CB&I
12005 Ford Road, Suite 600
Dallas, Texas 75234
Tel: 972.773.8400
Fax: 972.773.8401
www.CBI.com

Re: Pescadito Environmental Resource Center - Webb County
Municipal Solid Waste (MSW) Permit Application No. 2374
Permit Application – Clarifications to Second Technical Notice of Deficiency (NOD)
Tracking Nos. 14669041(19666994); CN603835489/RN106119639

Attachment III-F – Appendix III-F.1 (*Comment is provided by Mamadou Balde, P.G.*)

The subsurface conditions beneath the site are characterized as follows from the ground surface downward. See Figure 2 for a graphical representation:

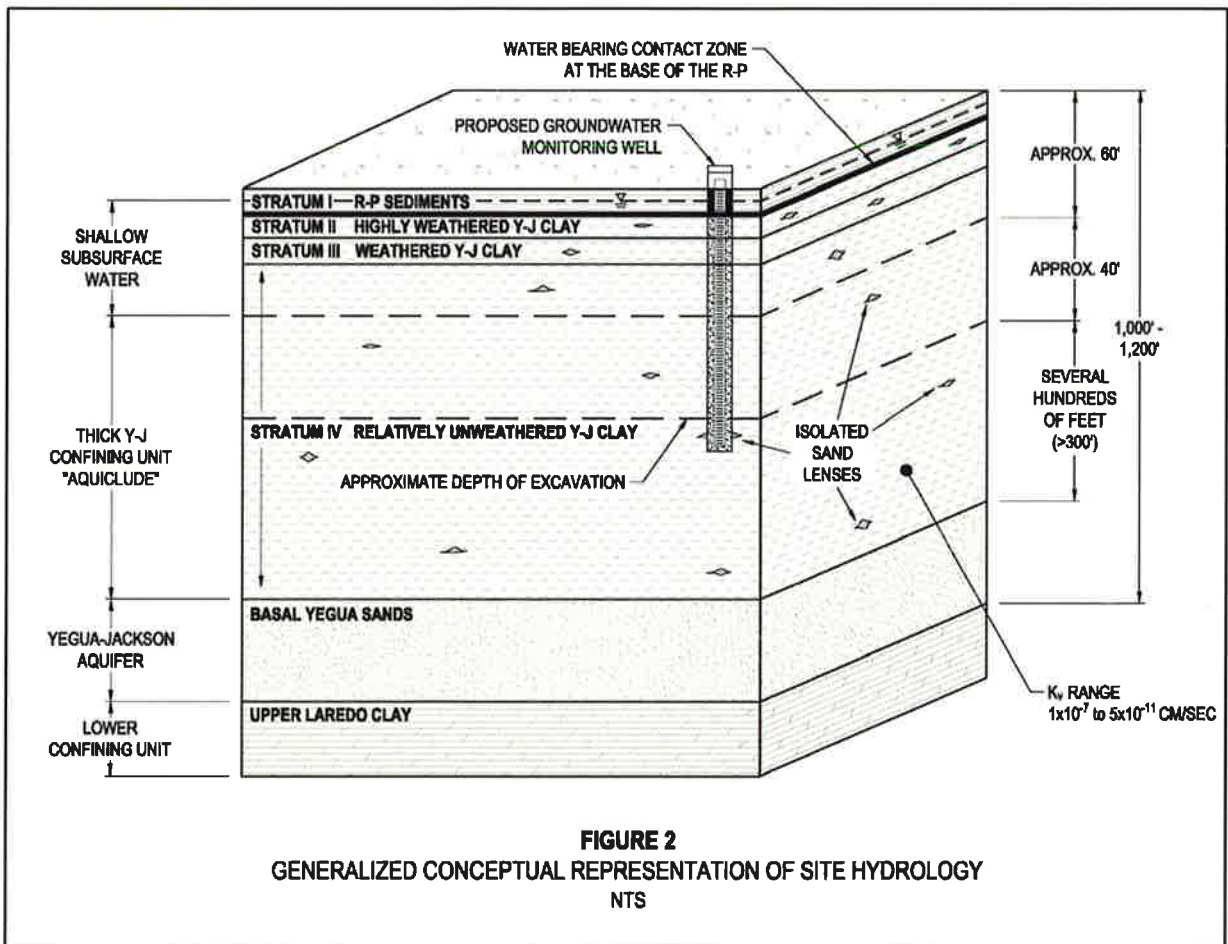
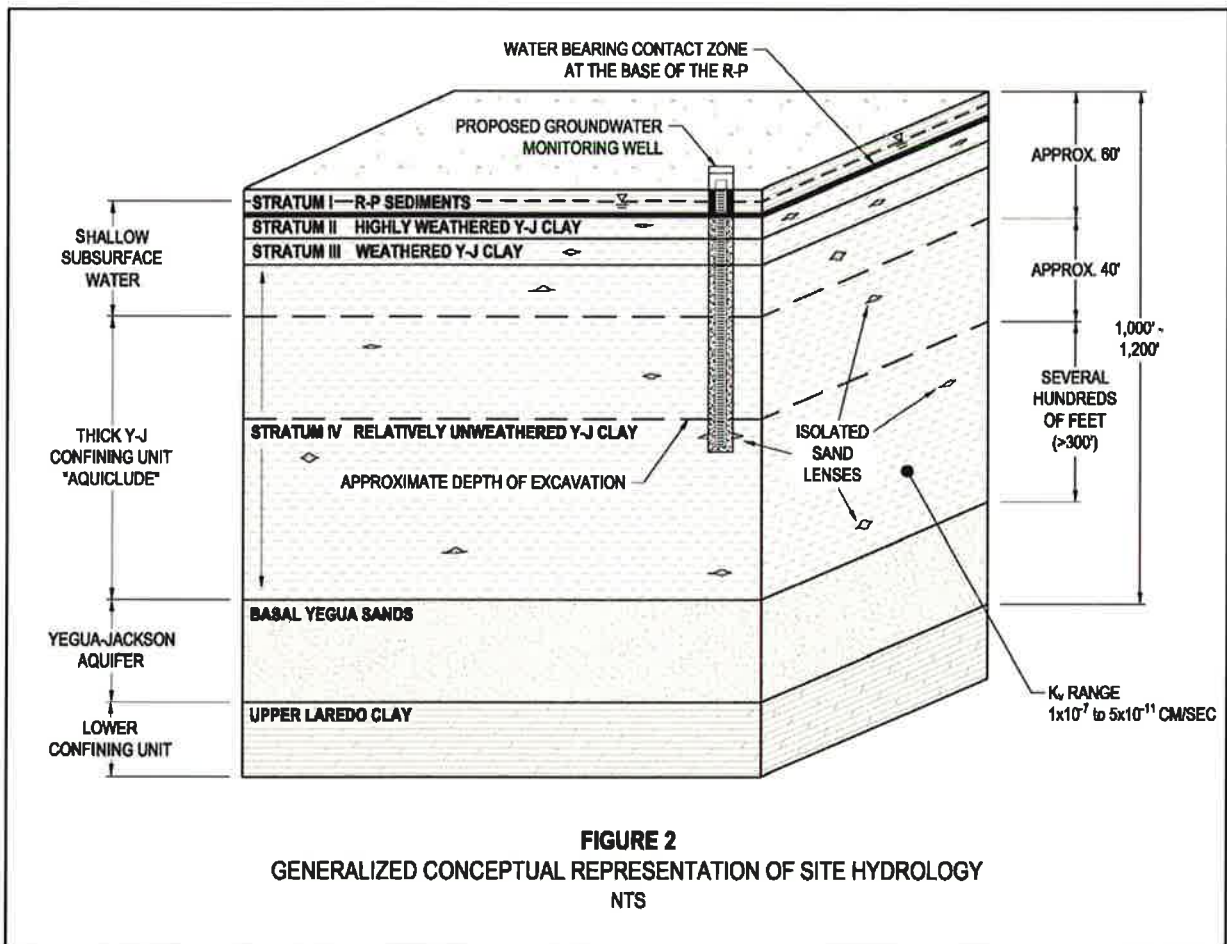
Water Contour Map) does not support the submitted model of site hydrology (Appendix III-E.2, {SIC Attachment III-E} Section 2.4) where the aquiclude is shown at 60 feet depth. It appears that the regulated uppermost aquifer extends downward at least several feet below the deepest excavation of about 100 feet. To ensure that all potential contaminant migration pathways are monitored in accordance with §330.403(a) and §330.403(e)(1), please reconsider the proposed depth of the groundwater monitoring wells as well as the monitored interval (Drawing III F.1-2). Please be aware that per §330.421(a)(2)(C), the 100-foot filter pack shown in Drawing III F.1-2 may not be considered as the monitored interval since the screen is limited to only the wells' bottom 10 to 20 feet.

The model (graphical representation) and text in Attachment III-E are supported by information provided in Appendix III-E.2. In particular, the water level contours shown on the Deep Water Contour Map (Figures 21 and 23 in Appendix III-E.2) along with the Shallow Water Contour Map (Figures 20 and 22) illustrate that there is a piezometric elevation difference between the 0 to 60-foot interval and the deeper section (Deep Water Contours being higher than the Shallow Water Contours) and confirms the presence of a confining layer below 60-feet. This has previously been discussed in Section 2.3 of Attachment III-E. Additional text has been included in Section 2.4 of Attachment III-E to further illustrate this. Although the clays in the upper 60-feet contain confining layer properties due to their low permeability, the contour maps discussed above are based on piezometers screened above 60-feet and those screened below. This is consistent with information provided in the Soil Boring Plan approved by the TCEQ on April 21, 2011. At the TCEQ's request Figure 2 in Attachment III-E "Geology Report" has been revised to indicate that the 60-feet to the aquiclude is approximate and the title has been revised to indicate a "Generalized Conceptual Representation of Site Hydrology".

As clearly shown in the application and as stated above, there is a confining layer below 60-feet; thereby separating the "Regulated Uppermost Aquifer" as defined in the application (0 to 60 feet below ground surface) from the deeper soils. The fact that there is some limited amount of water in the soils below 60-feet does not preclude that interval from being an aquiclude (See Federal definition as provided in the text on page 6 of Attachment III-E).

TYPICAL GROUNDWATER MONITORING WELL DETAIL

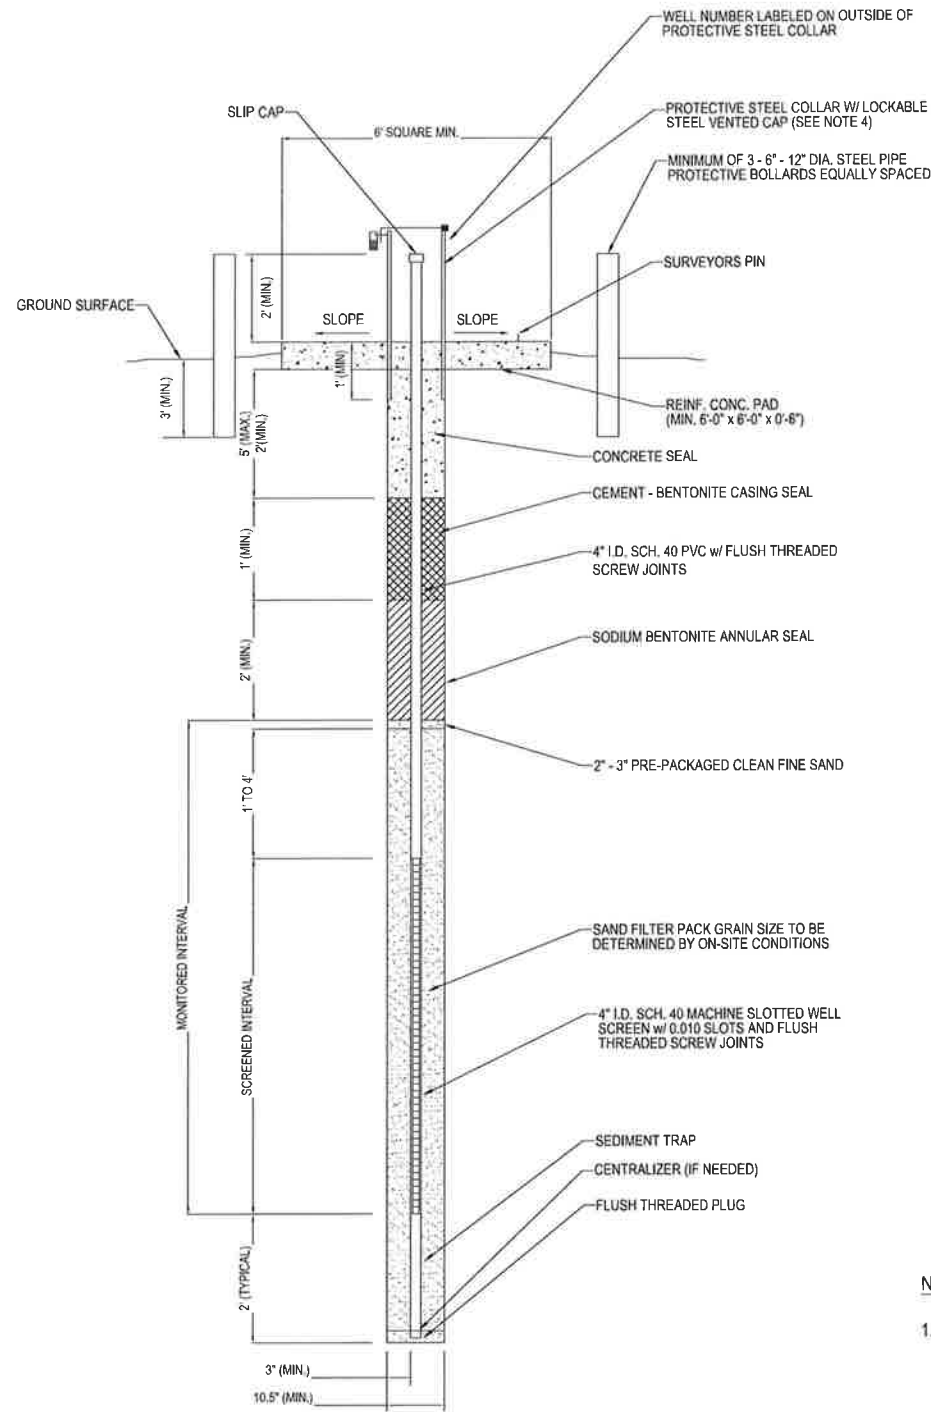
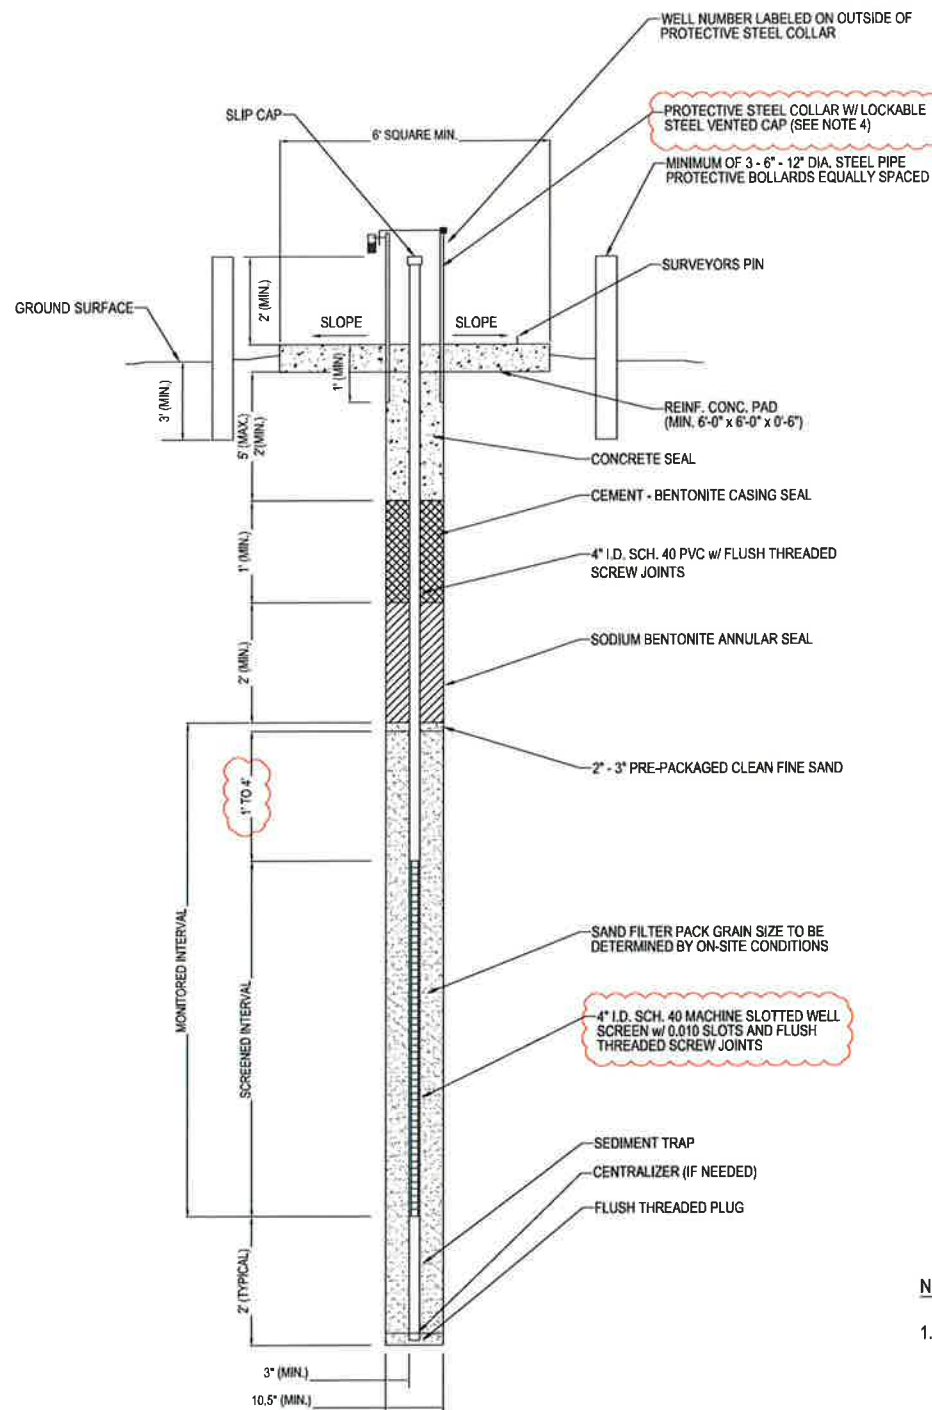
1. The presence of groundwater in Layer IV as demonstrated by the observed static water level for the screened intervals of 60 to 113 feet (*Attachment III-E.2, Figure 21: Deep*

Per your request, we have reviewed the depth of the proposed groundwater monitoring wells and have found them to be to the appropriate depth. Additionally, we have modified the text in Attachment III-F and Drawing III-F.1-2 in Appendix III-F.1 to show the monitor well screen to extend from the bottom of the excavation to within a few feet of the surface; thereby creating a screened (monitored) interval the full depth of the well. It has always been part of the application to monitor the full depth of the monitoring well. Based on our meeting, providing a screen as well as a filter pack for the full depth addresses your concerns.

1. MONITORING WELL INSTALLATION SHALL CONFORM TO METHODS AND MATERIALS DESCRIBED IN APPLICABLE REGULATIONS OF TCEQ.
2. PTFE TAPE OR O-RINGS ON ALL JOINTS.
3. MONITORED INTERVAL TO BE FROM 9' BELOW GROUND SURFACE TO THE DEEPEST SUMP EXCAVATION ELEVATION NEAREST TO THE WELL.
4. PROTECTIVE COLLAR AND CAP MAY BE STEEL OR ALUMINUM.
